<b>T.I. no.:</b> 2021 - 06 <b>Updated:</b> -	<b>Topic:</b> Twin Milk hose guide
---	------------------------------------

### Twin Milk hose guide standardised across platforms

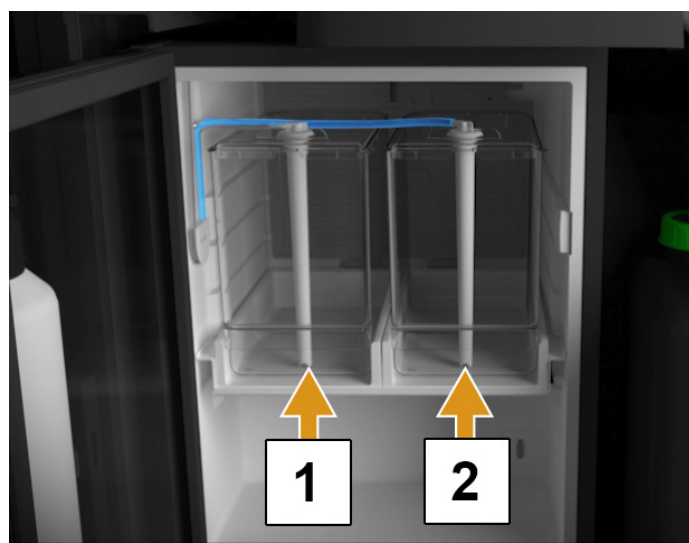
The milk hoses for the Twin Milk were installed differently in the past on the SCS/SOUL compared to the SPCC.

From serial number 2105/XXXX, installation of the milk hoses of the SPCC takes place in the same way as for the SCS/SOUL.

- Milk 1, left, hose colour white.
- Milk 2, right, hose colour blue.

With this measure, the milk hose guide is the same across platforms and corresponds to the screen animations.
